American Telecommunications Certification Body Inc.  
6731 Whittier Ave, McLean, VA 22101

RE: Windigo SYSTEMS  
FCC ID: QQFPBTCRMRYC2-X

After a review of the submitted information, I have a few comments on the above referenced Application.

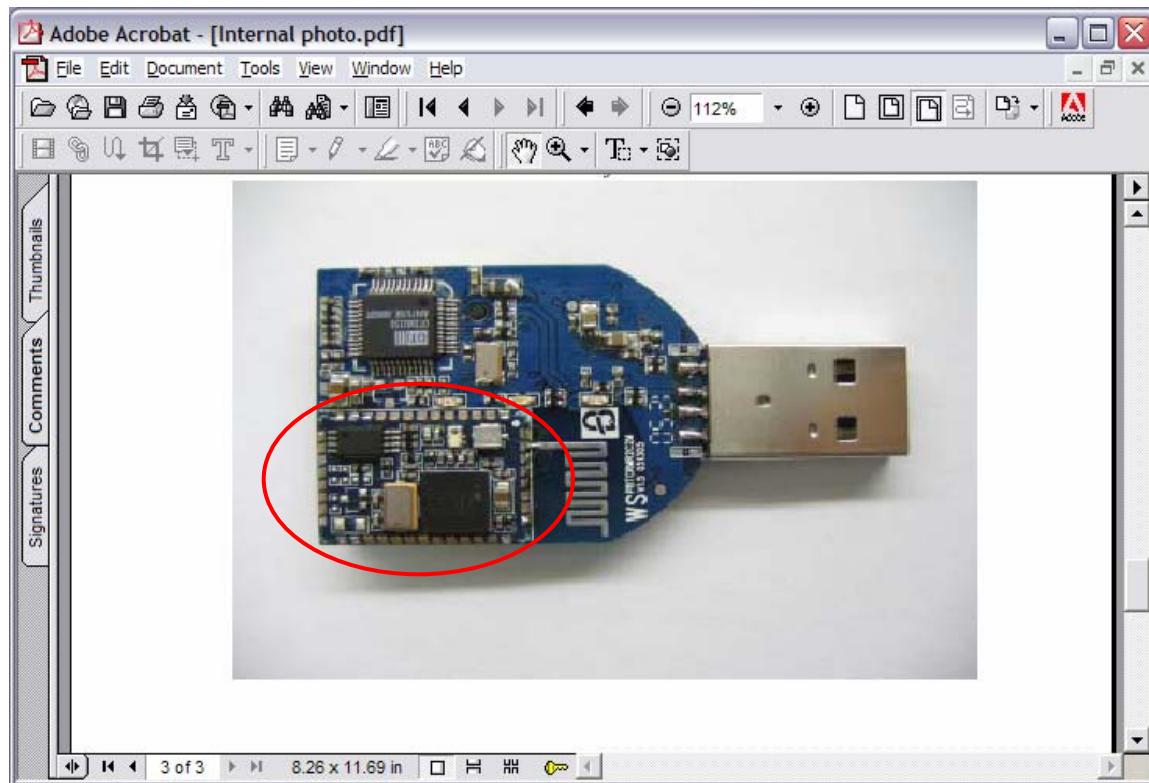
- 1) Please provide bottom view of the RF module/board shown:
